ADDENDUM NO. 4

RFQ CCC-056

**New Student Services Building
Compton Community College District**

tBP Project. No. 20987.00

A9-2
drawing of

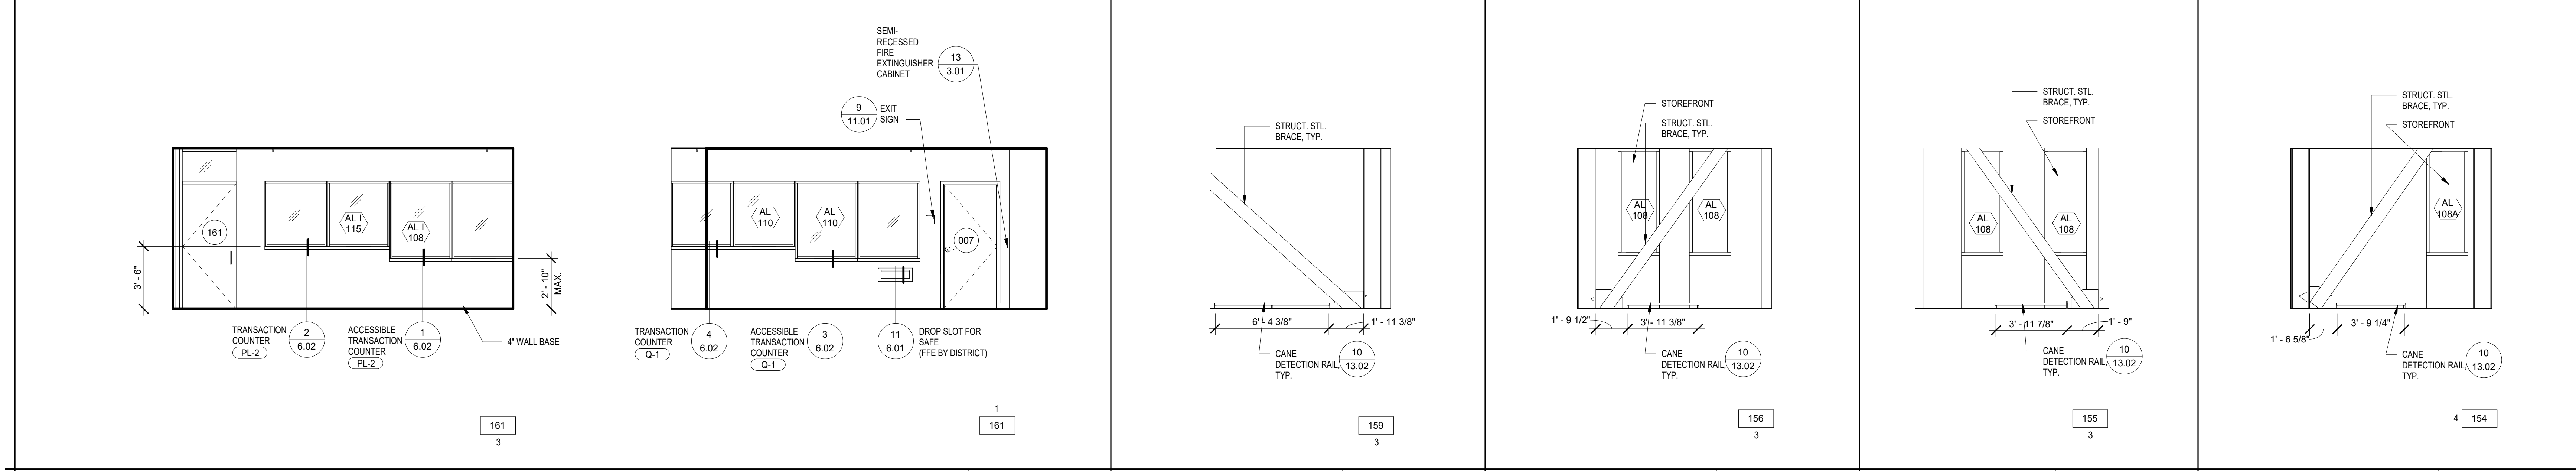
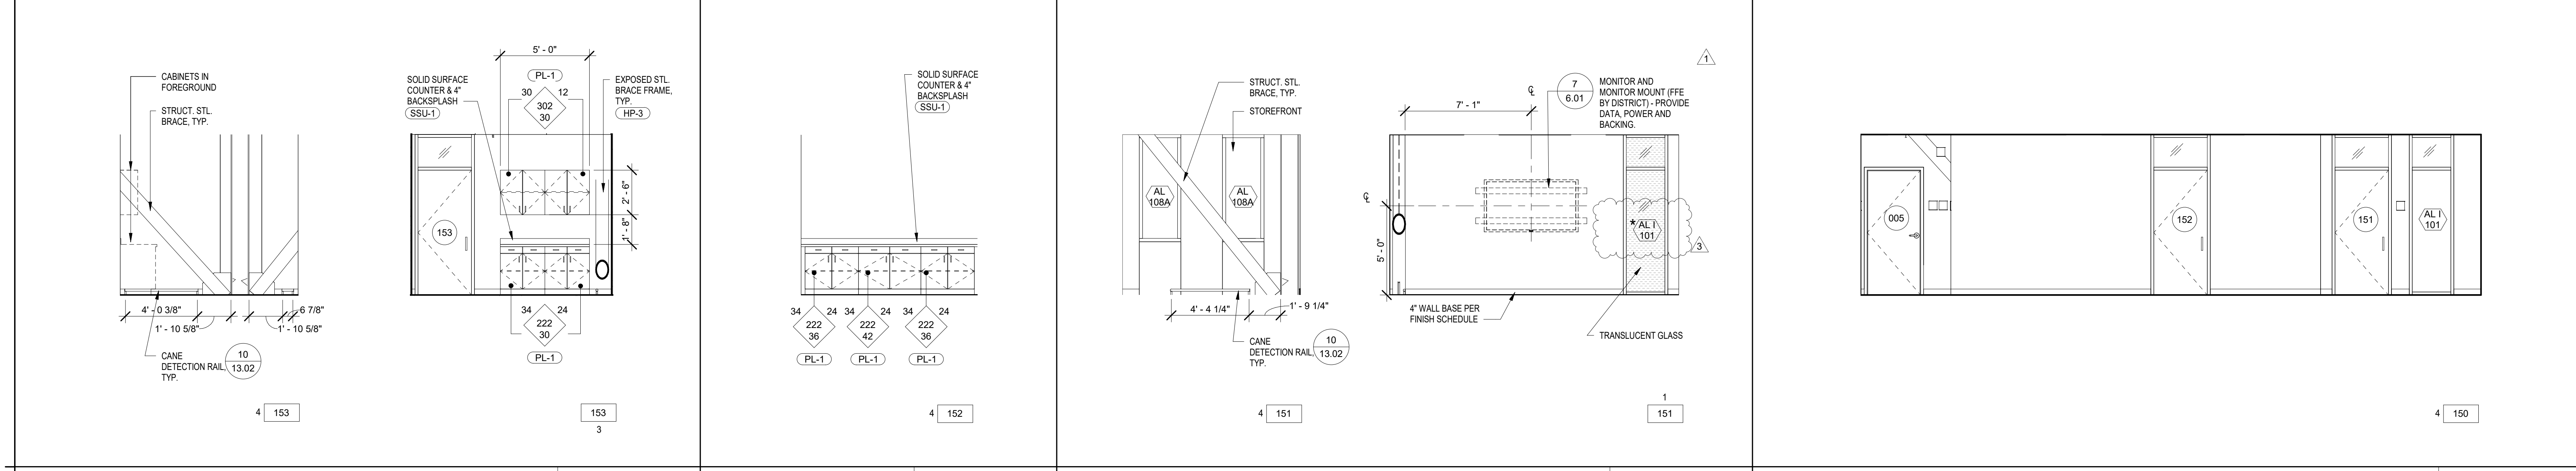
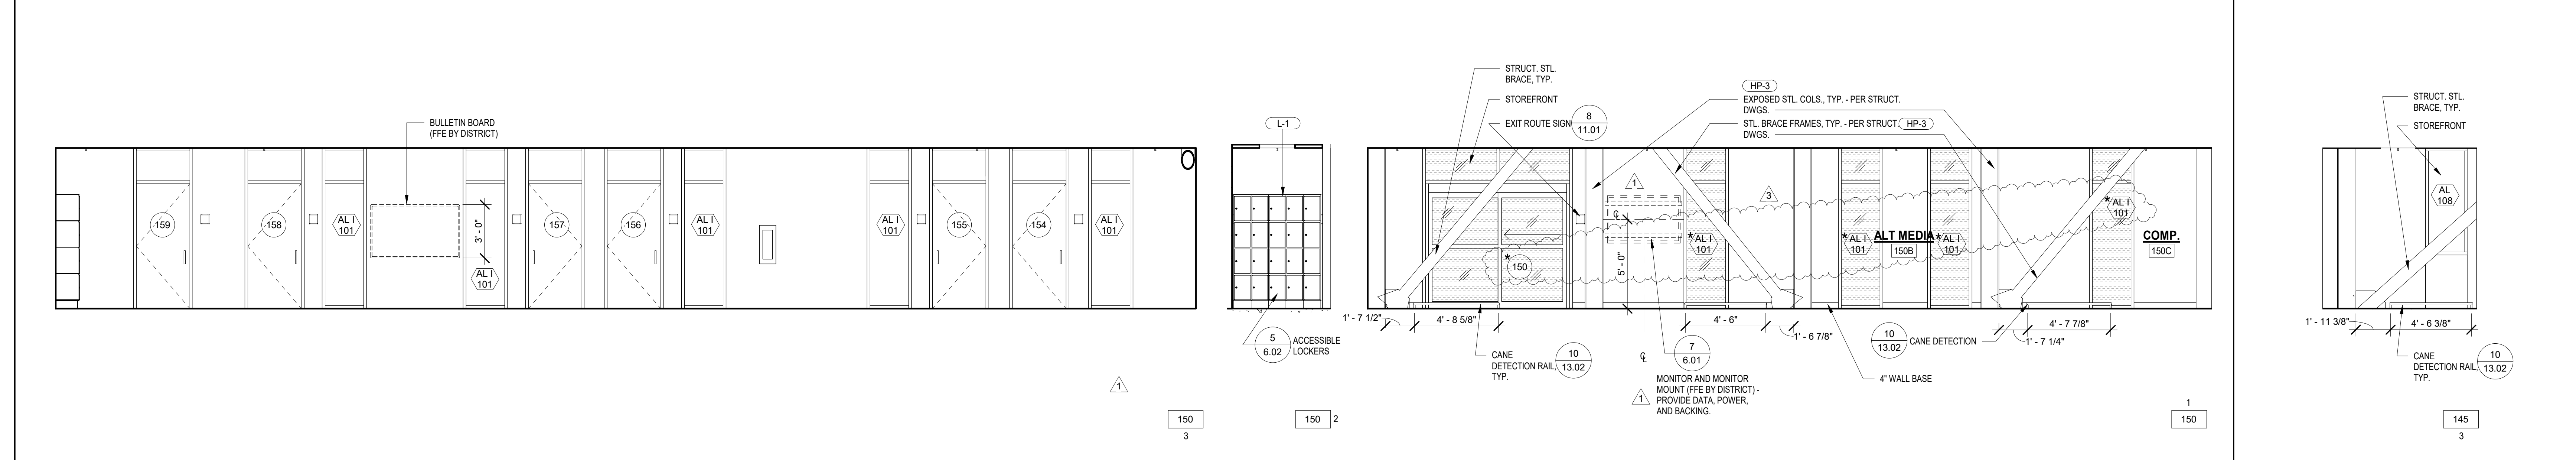
8. Revised SHEET A9-2 INTERIOR ELEVATIONS
 - a. Added window/door types to elevations.

A9-4
 drawing of

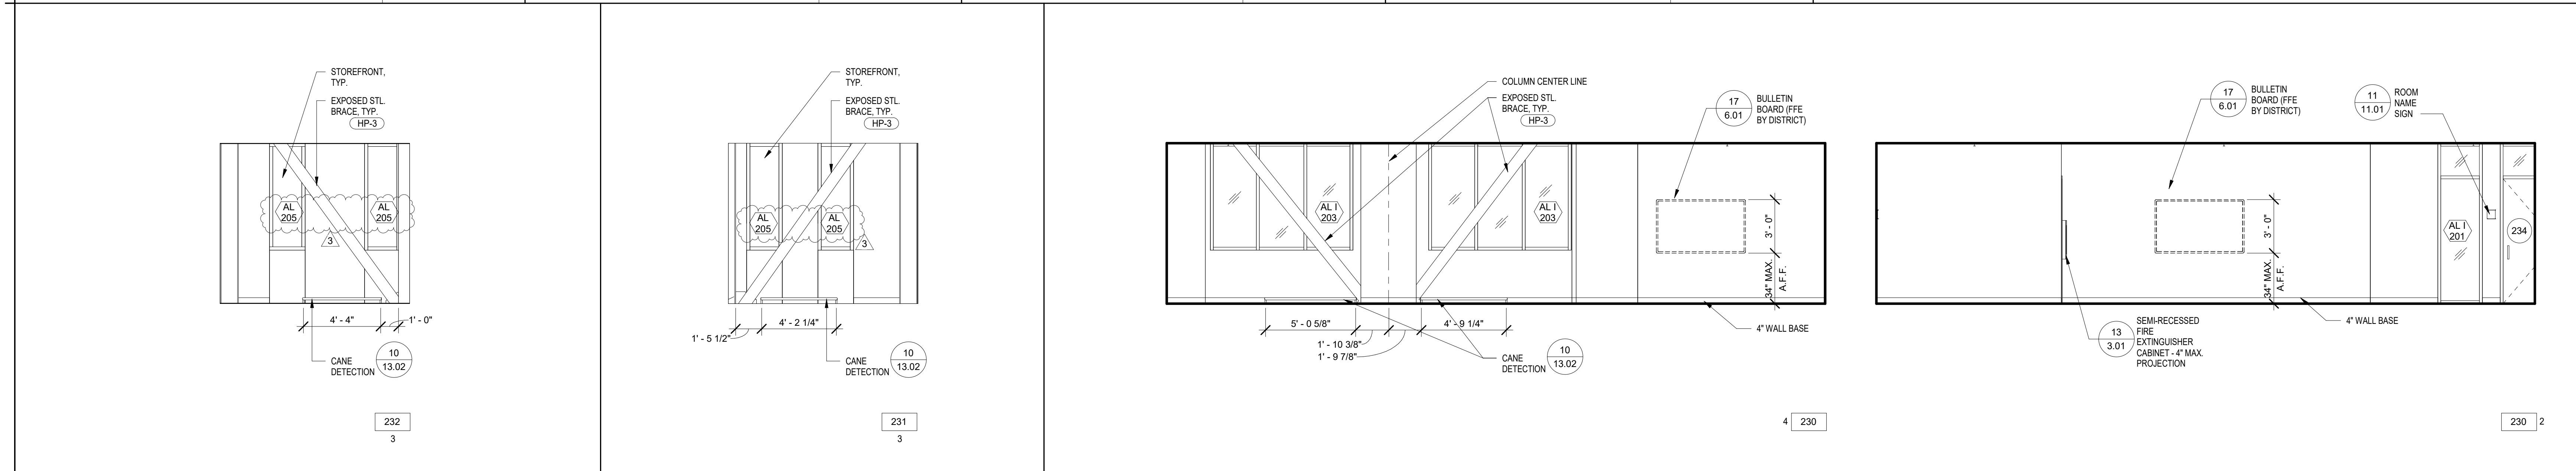
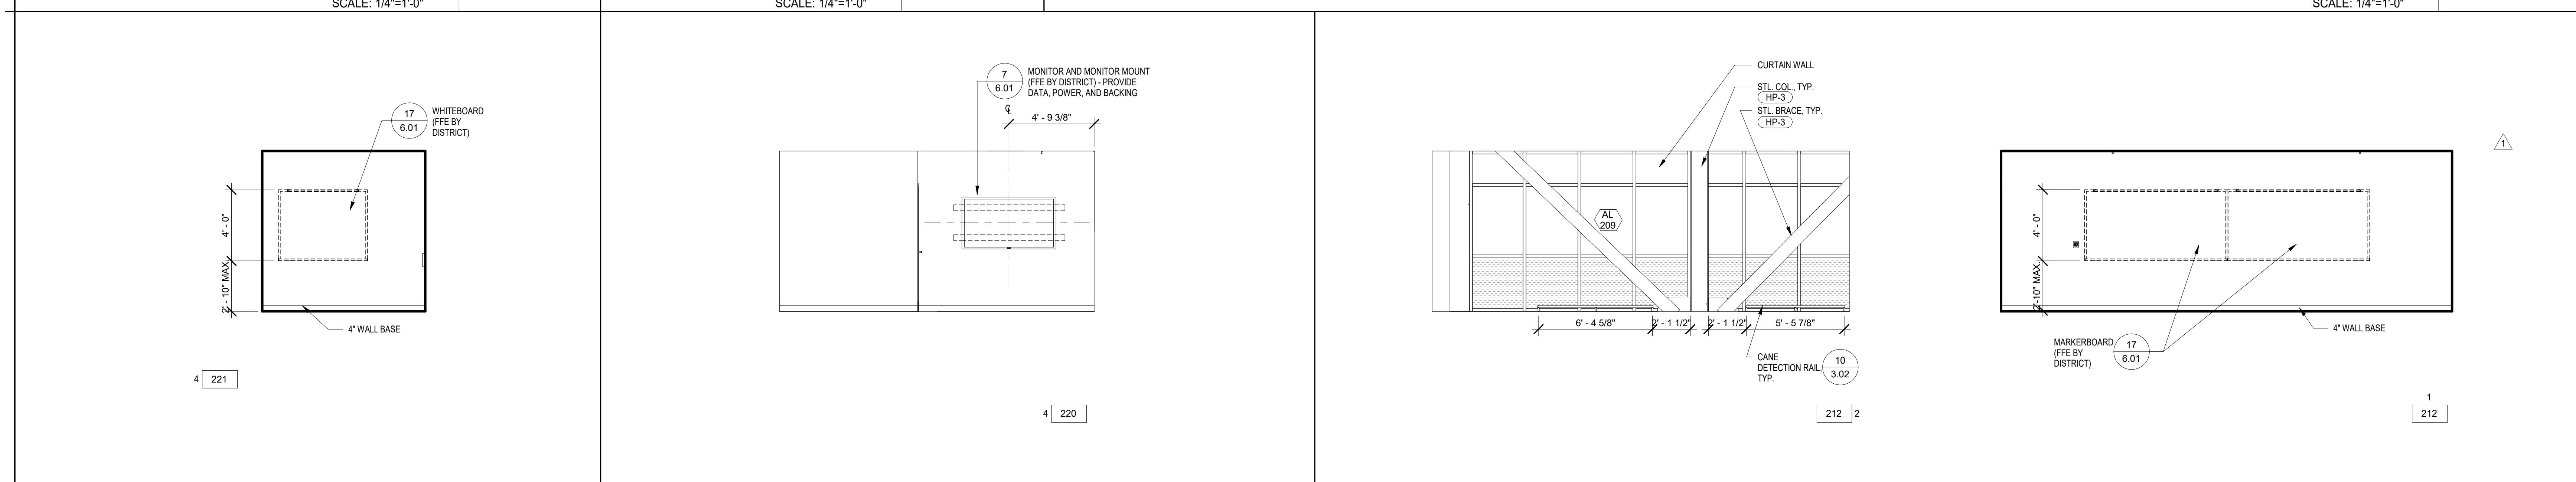
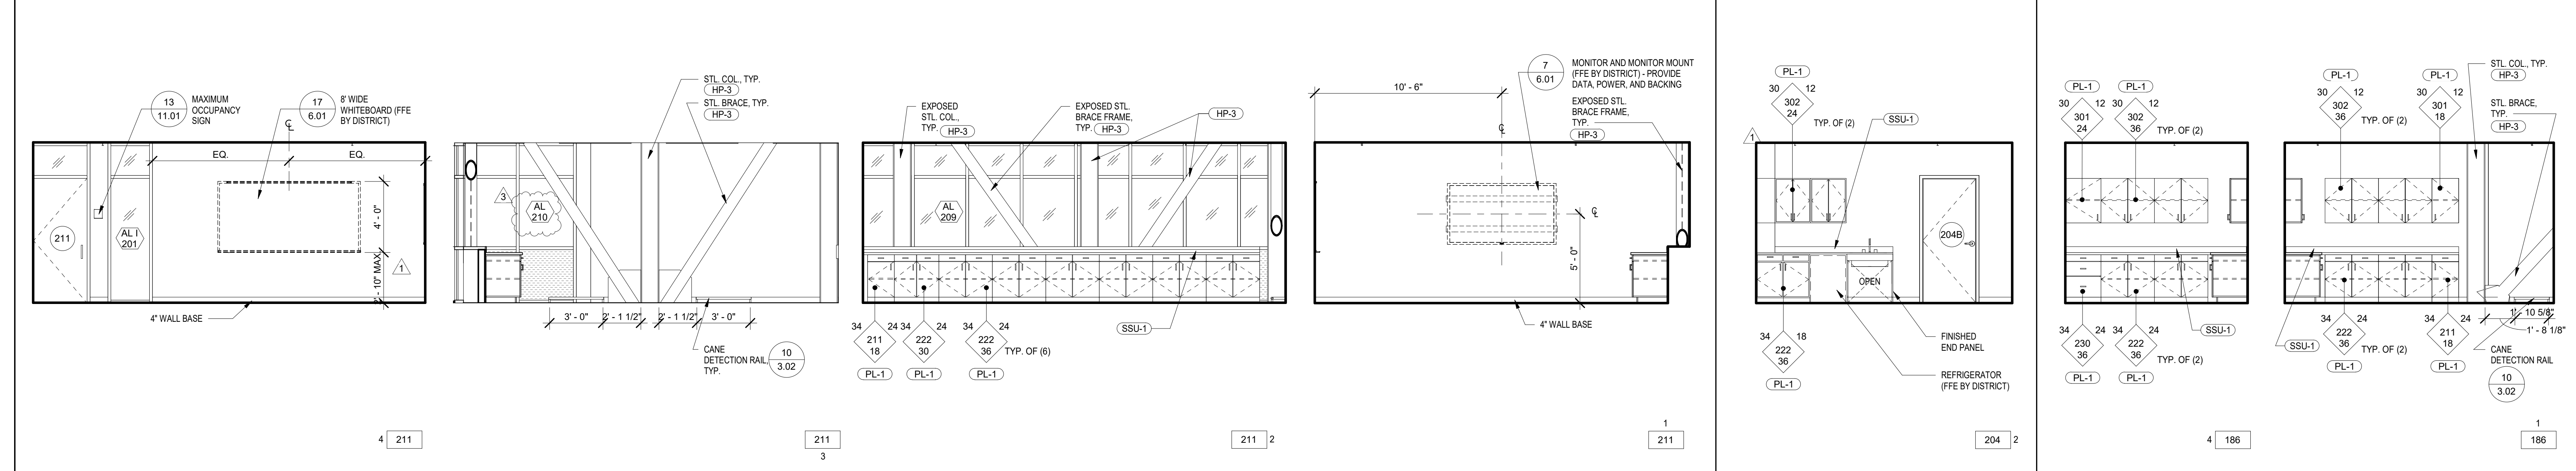
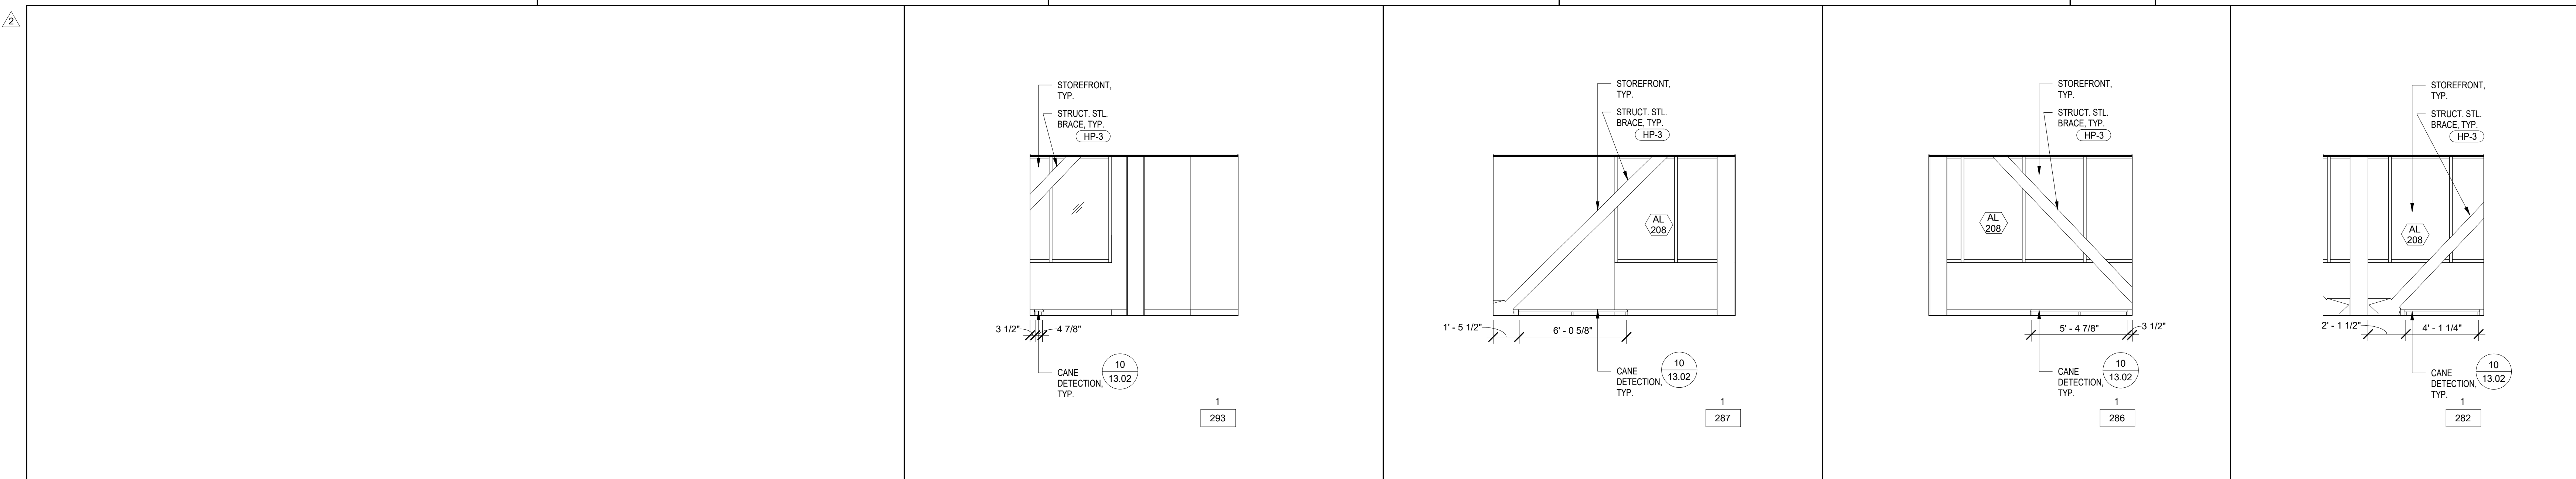
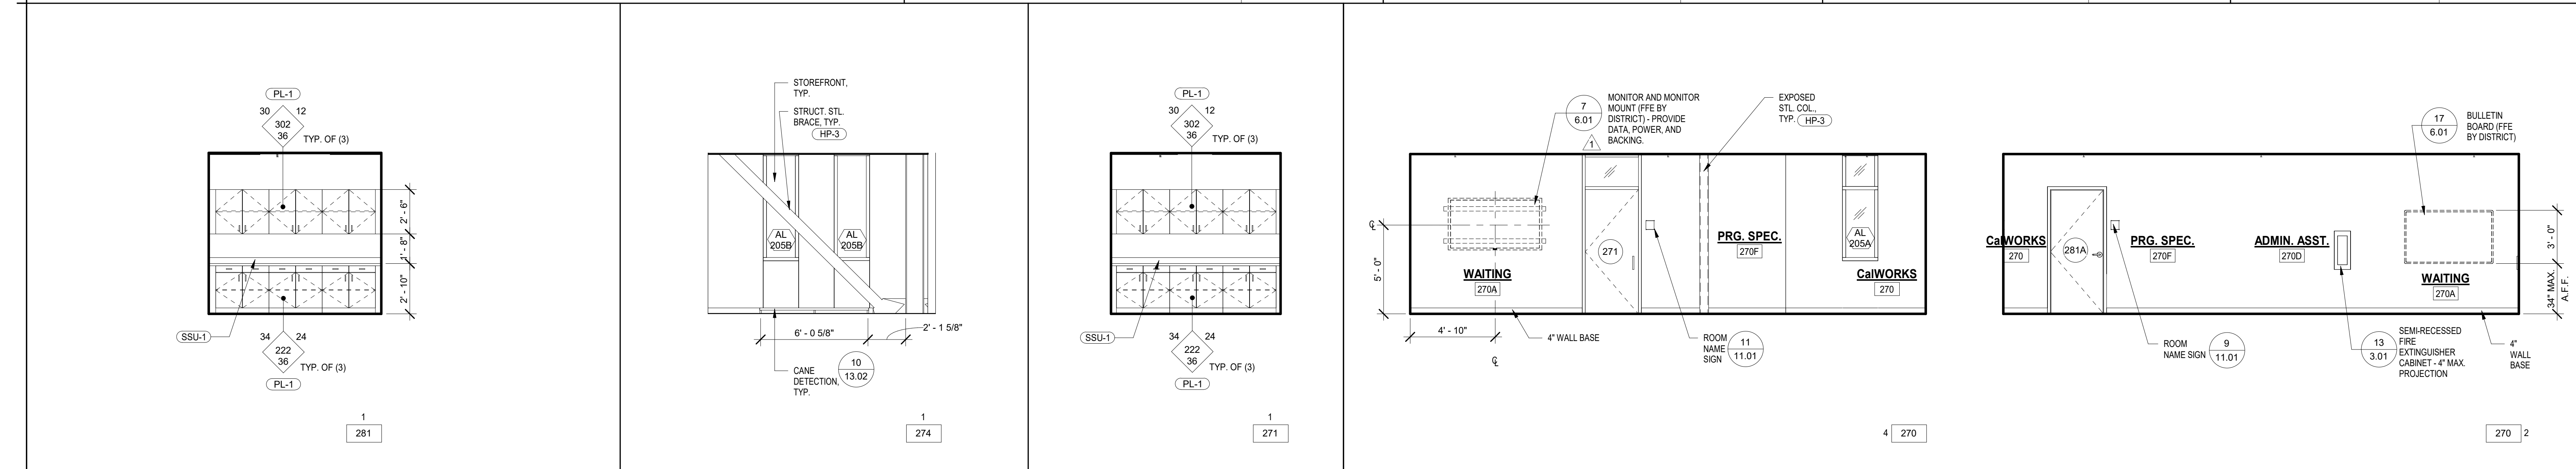
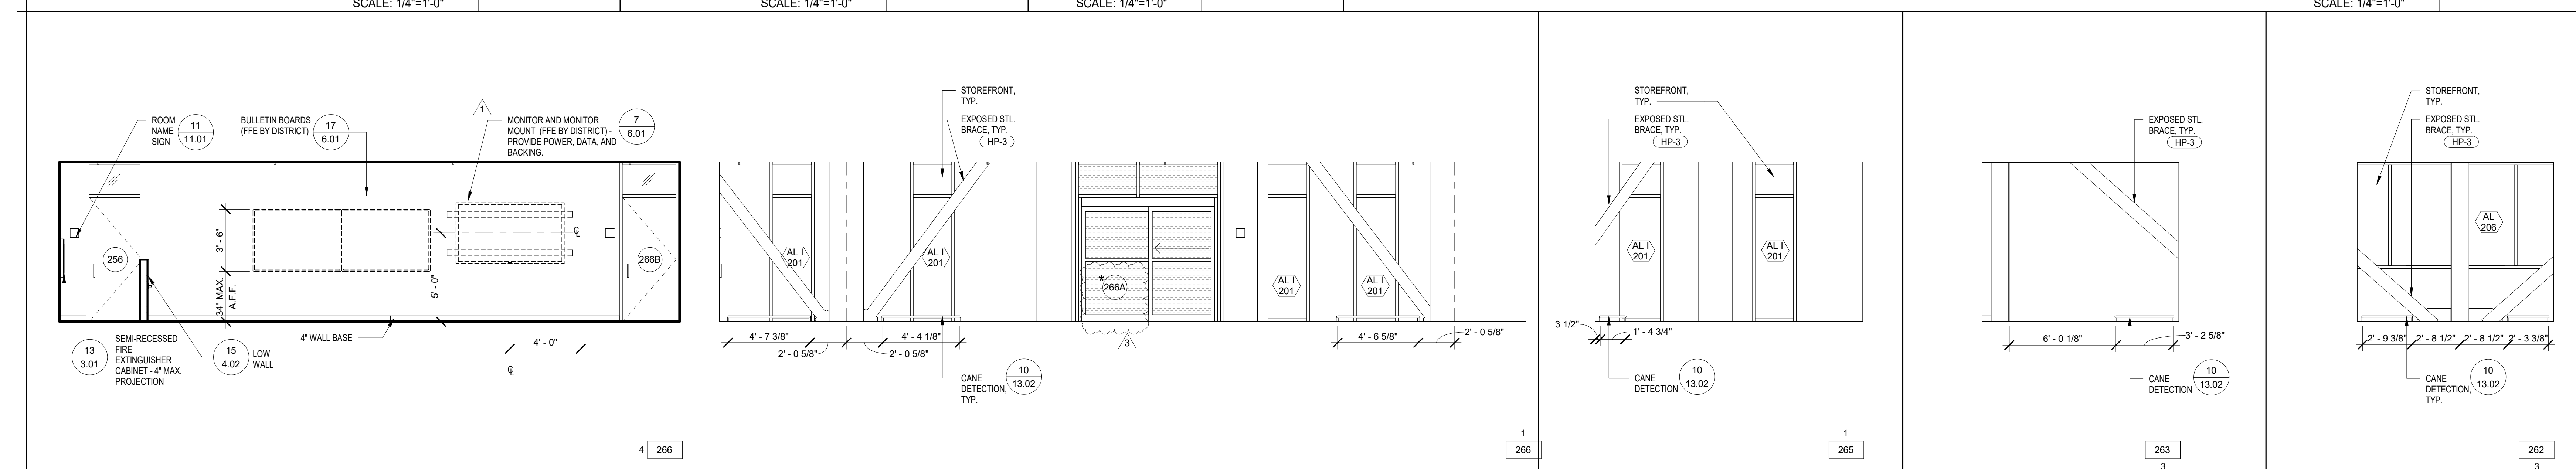
10. Revised SHEET A9-4 INTERIOR ELEVATIONS
 - a. Added window/door types to elevations.
